WATER QUALITY MEMORANDUM

Utah Coal Regulatory Program

RE: 2003 Fourth Quarter Water Monitoring, Energy West Mining Company, Trail Mountain Mine, C/015/0009-WQ03-4, Task ID #1795

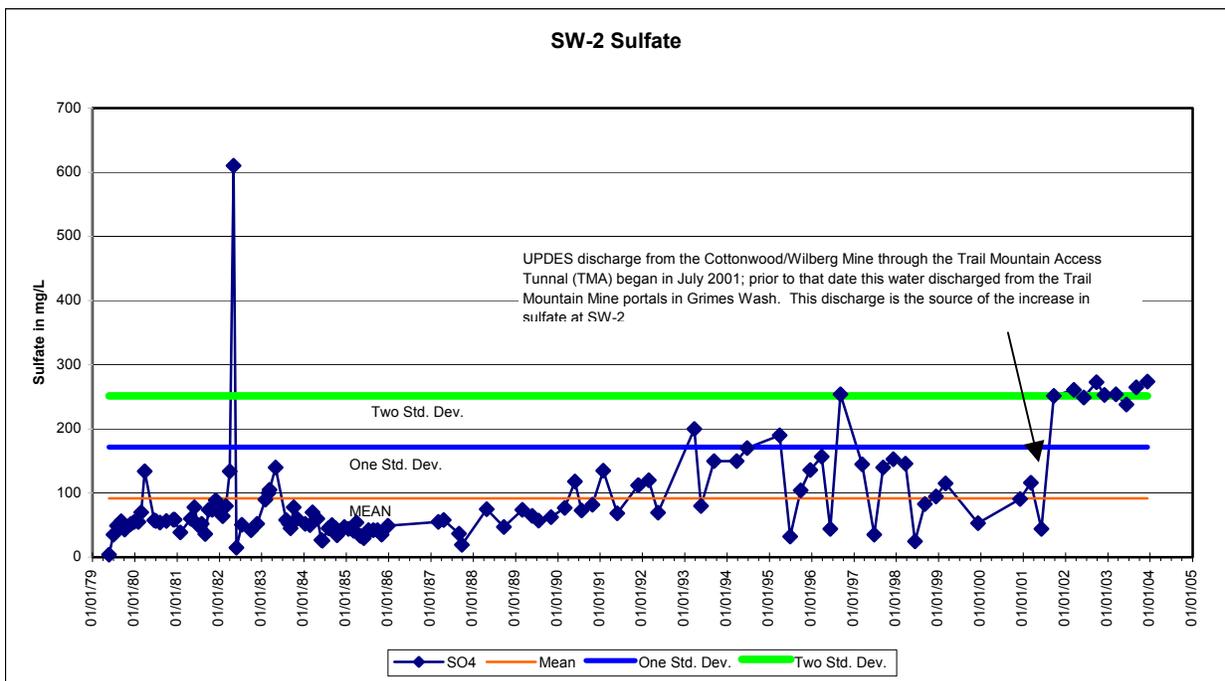
SW-2 December: SO₄ (n = 117) was outside the two standard deviation range. (See the chart at the end of this report.)

SW-2: the Permittee has identified the UPDES discharge from the Cottonwood/Wilberg Mine through the Trail Mountain Access Tunnel (TMA) as the source of the sulfate: prior to July 2001 this water discharged from the Trail Mountain Mine portals in Grimes Wash. No action is needed at this time.
